STAFF RECOMMENDATION

921 Benton Avenue

May 15, 2019

Application: New Construction – Addition and Outbuilding

Figure 5: Proposed east elevation. Note how the addition, though very deep, sits lower than the historic house. Also note that the attached garage is fully at basement level.

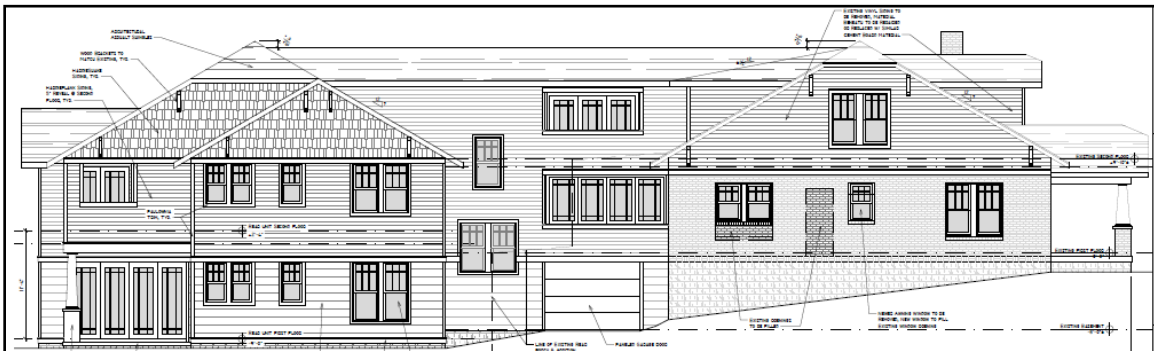
The plans call for some changes to original openings on the east side elevation, which is considered partial demolition. (Figures 2 & 5) The paired windows beyond the door will be shortened, but will

Height & Scale: The proposed addition takes advantage of the grade to provide a full two-story addition, which is set lower than the historic house. A rear-facing gable ties into the back of the historic side-gabled roof form, about nine inches (9”) below the ridge. It ties into the hipped roof of the addition which peaks about one inch (1’) lower than the historic ridge.

The footprint of the addition steps in about eleven feet, five inches (11’5”) on the east side to accommodate the basement-level attached garage portion of the addition. After about twenty-three feet (23’), the addition steps back out flush with the historic side wall. On the west side, the addition steps in two feet (2’) for a distance of two feet (2’) and then steps out about seven feet (7’) wider than the historic house. Because the lot is sixty feet (60’) wide and because the house is slightly off-set on the lot, the guidelines allow for the addition to step wider. The seven foot (7’) wider section is about eighteen feet

(18') deep and then steps back in. The main wall of the addition is flush with the historic wall, but contains a second wider section that is about fifteen feet (15') deep and steps out six feet (6') from the historic side wall plane. The sections of wall that step wider appear to be one story in height, as viewed from Benton Avenue, due to the slope. (Figure 4) The roofs are clipped side gables, to further temper the perceived height. Staff appreciates the thoughtful

The depth of the addition is significant – it will add approximately forty-seven feet, six inches (47'6") to the existing footprint and will result in a house that is approximately one-hundred-fourteen feet (114') deep. Staff finds that the depth could be appropriate as the current footprint – including non-historic additions- is approximately sixty-seven feet (67') deep, so the addition will less than double the current depth. Also, the lot is exceptionally deep at about two-hundred-eighty-eight feet (288') deep.

Outbuildings: The plan includes a basement-level attached garage which will be accessed via the existing driveway. (Figure 5) The guidelines allow for such a garage. Additionally, a new detached outbuilding at the rear of the lot is also proposed.

Staff finds that the project meets section IV.B. for additions-massing.
